Re: Cherokee Nation WW Hastings Replacement Hospital - Addendum 02 Narrative

Following is a list of revisions included in Addendum 02.

PROJECT PHASE:
BID PACKAGE 02
(SITE DEMOLITION AND UTILITIES)

JOB NUMBER: 21-08.21
DATE: 10-21-2022
SHEET NUMBER:

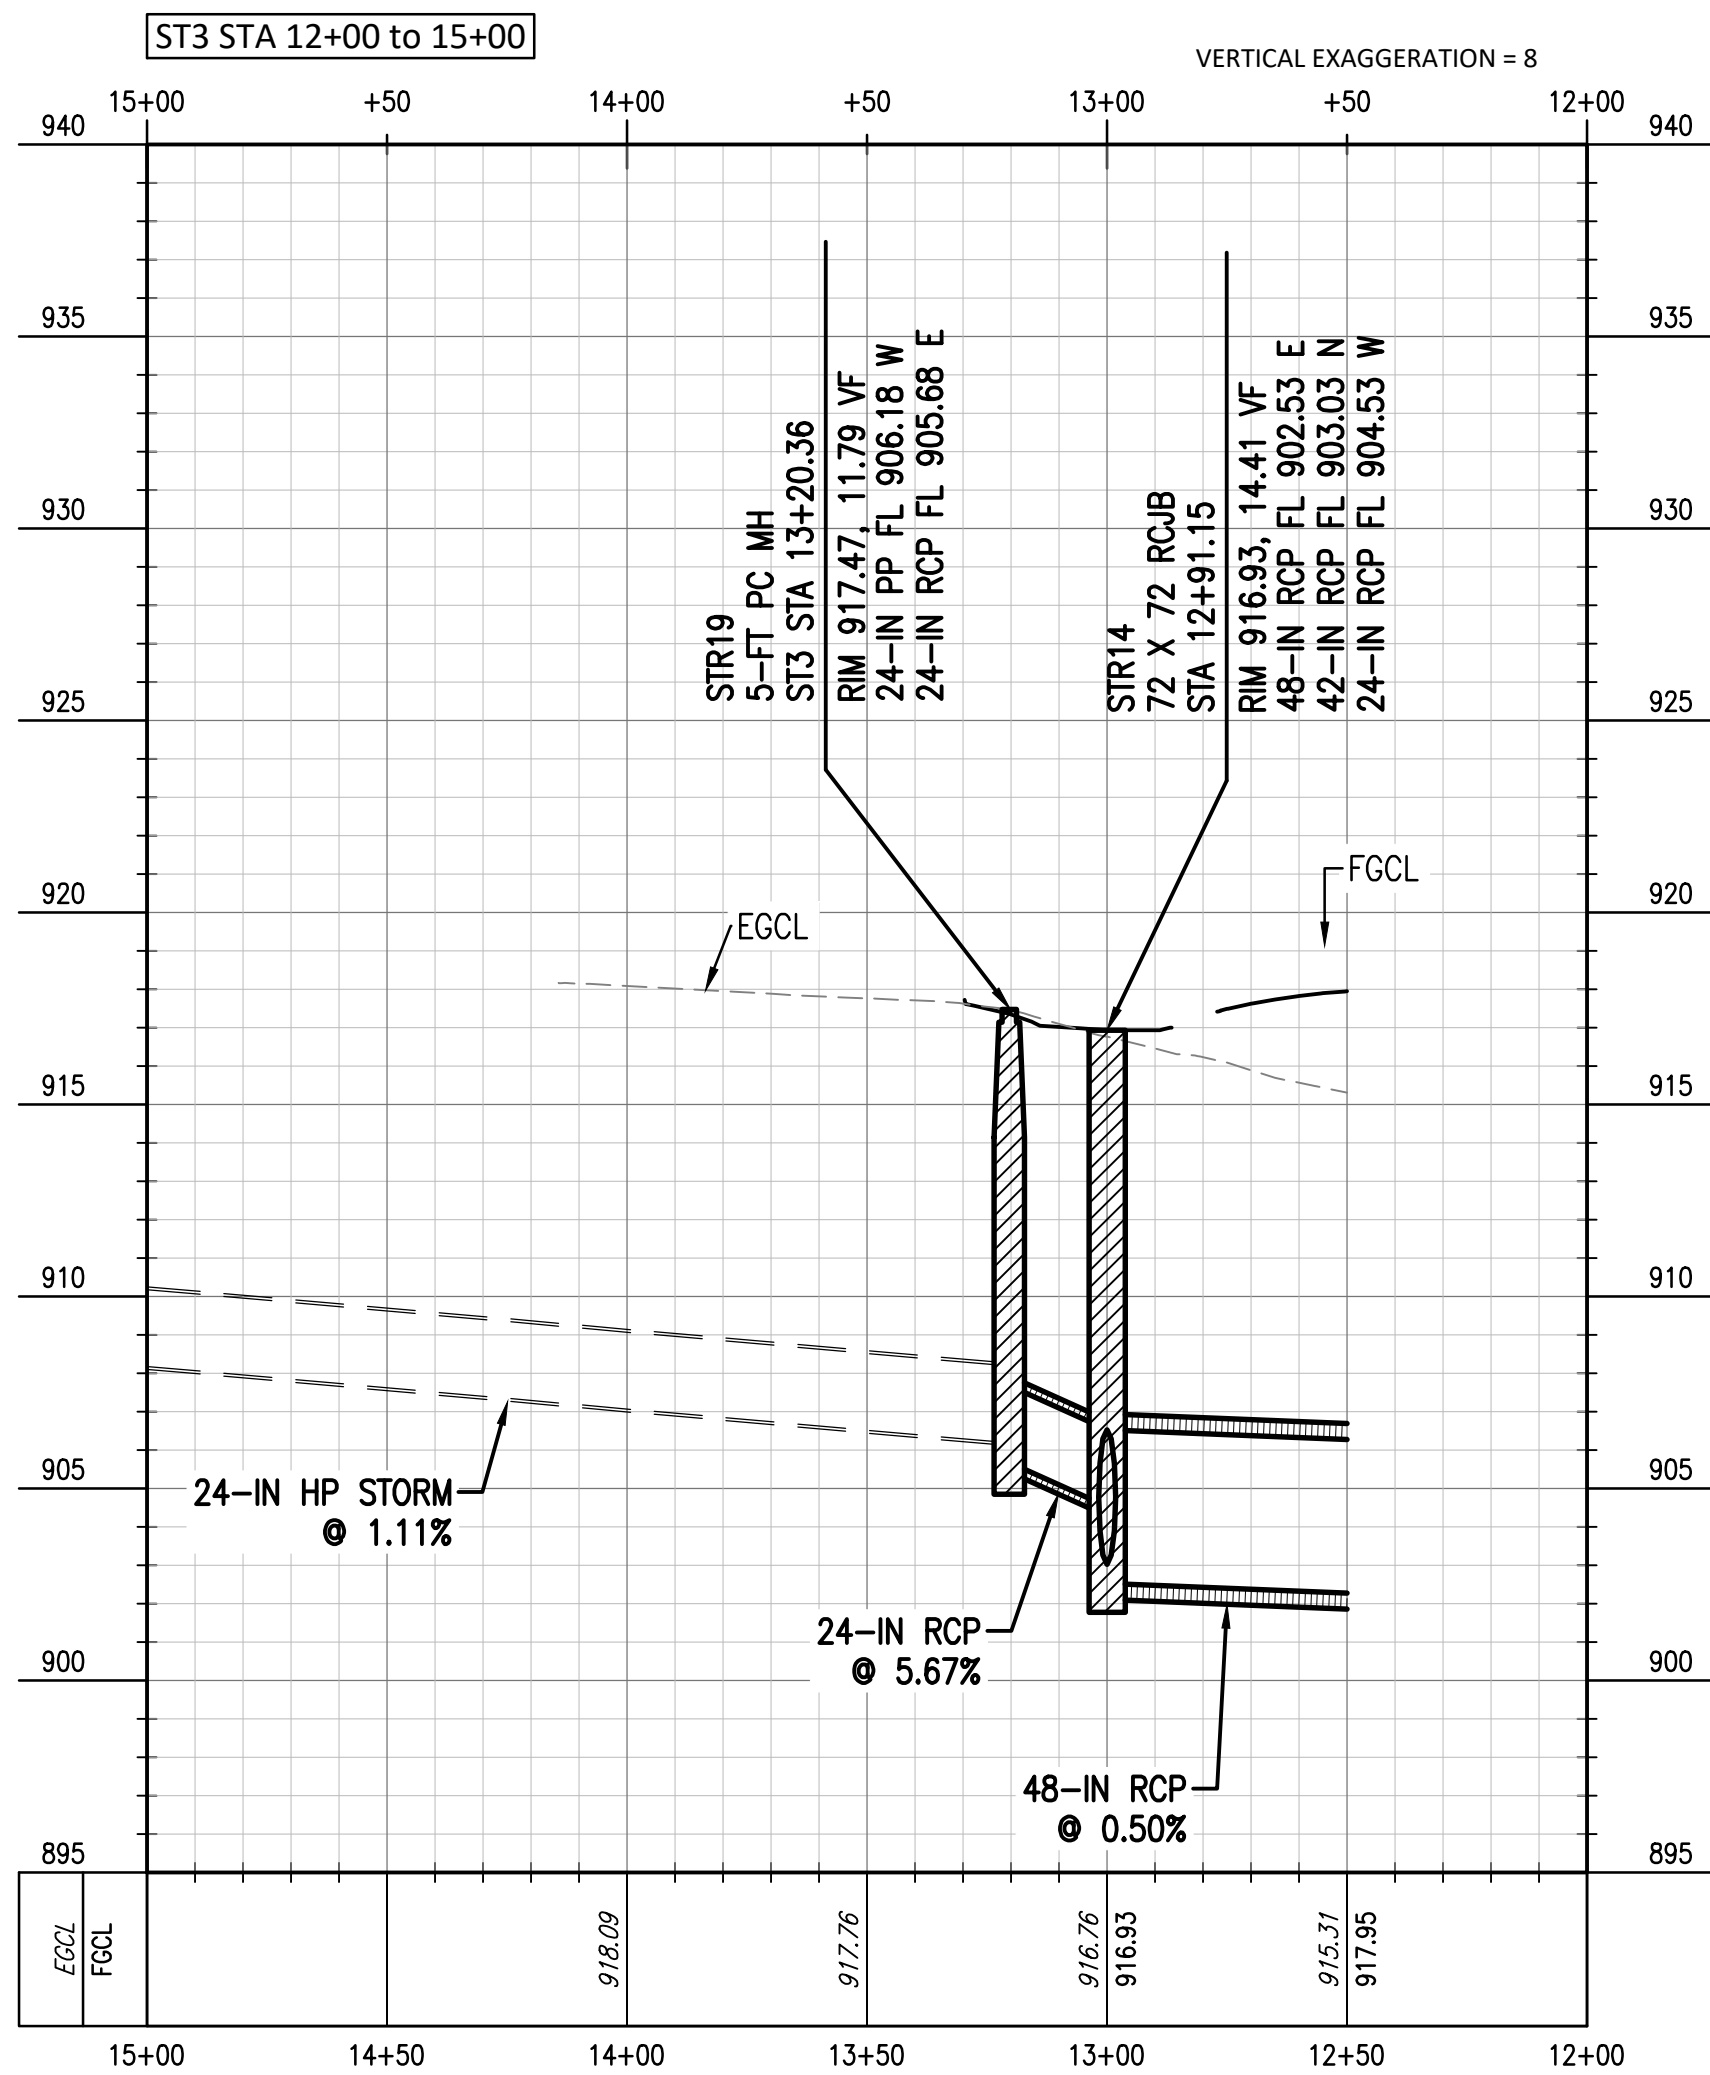
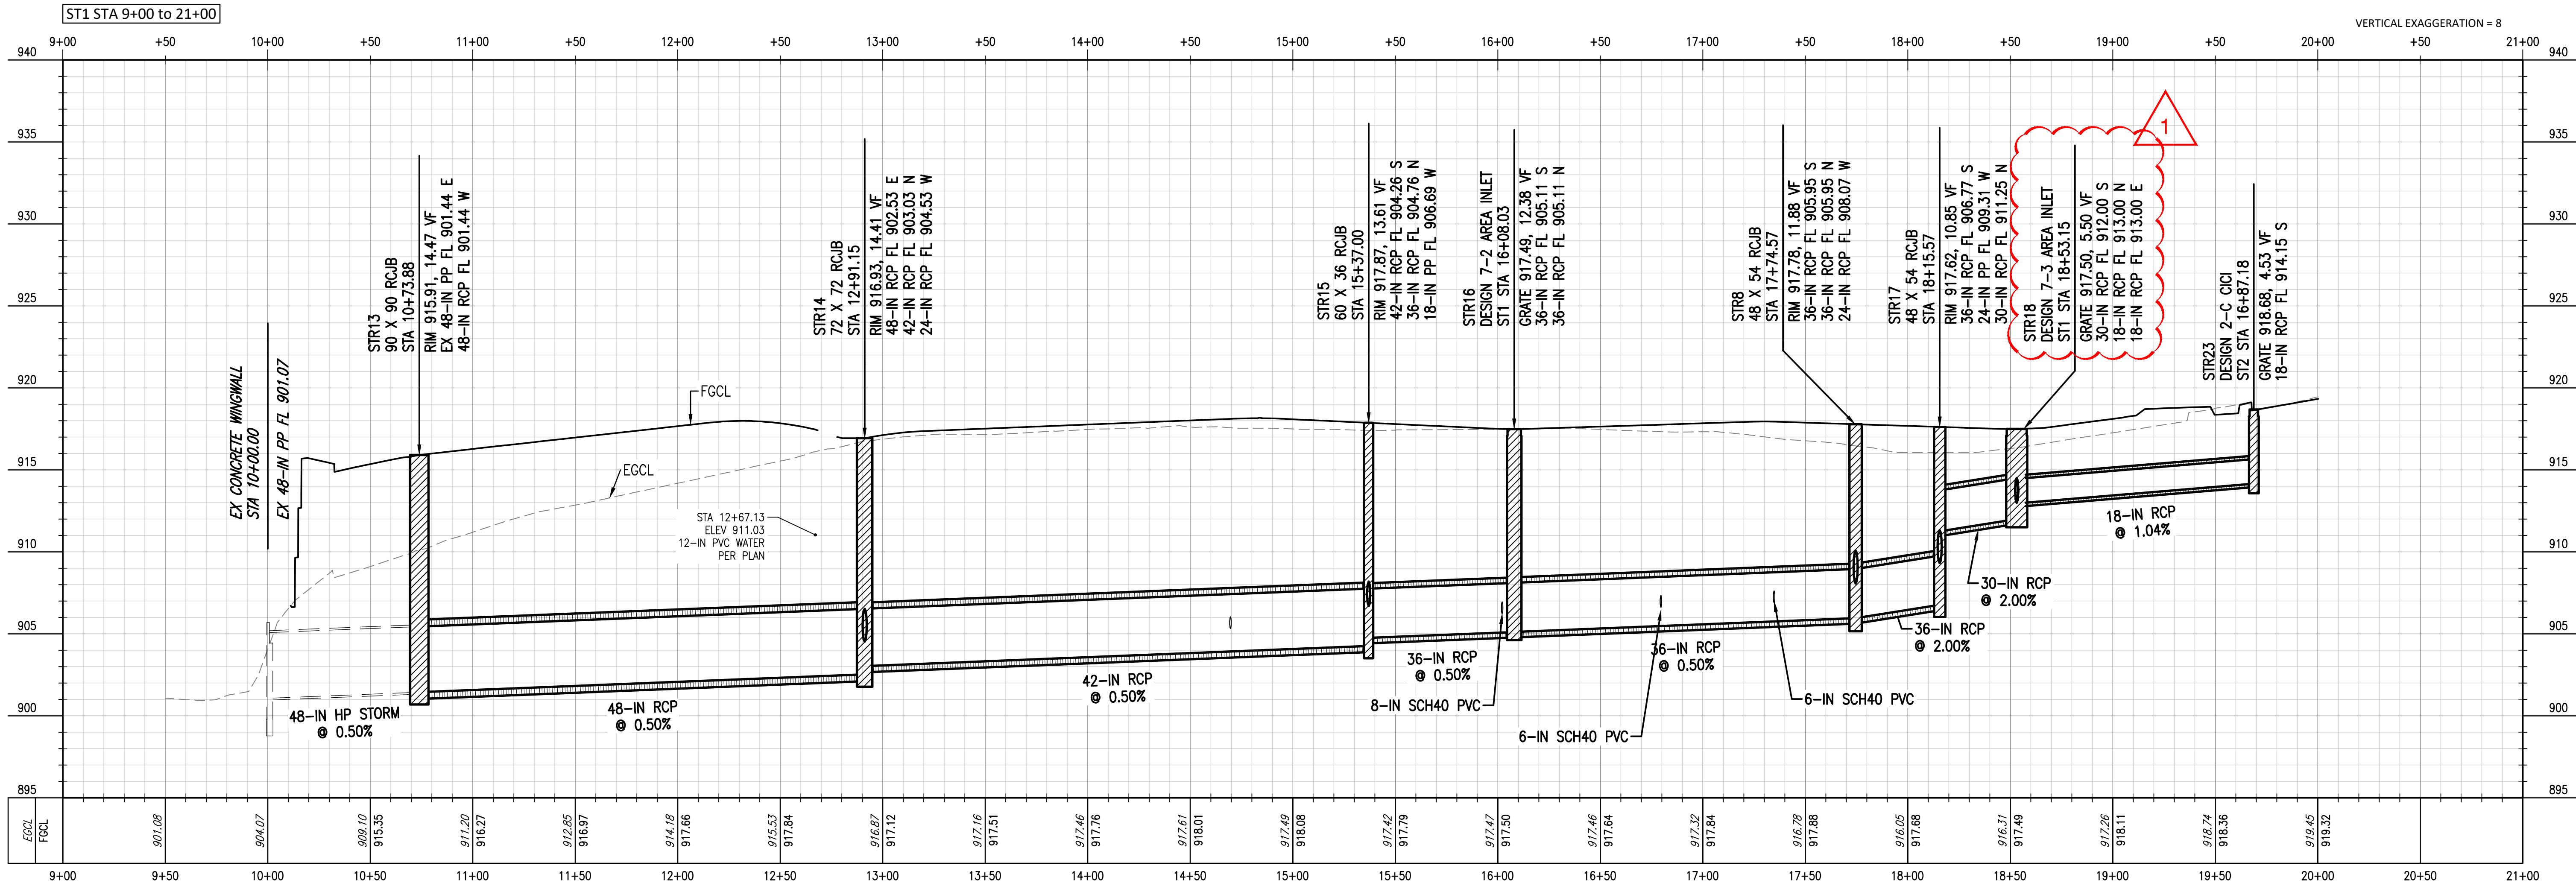
- C6-103 - Revised pipe connections to storm sewer for the lower storm sewer.
- C6-203 - Added label to STR18.
Corrected STR22 to connect the existing storm sewer pipe to the manhole.
Existing water line shown in profile ST5.
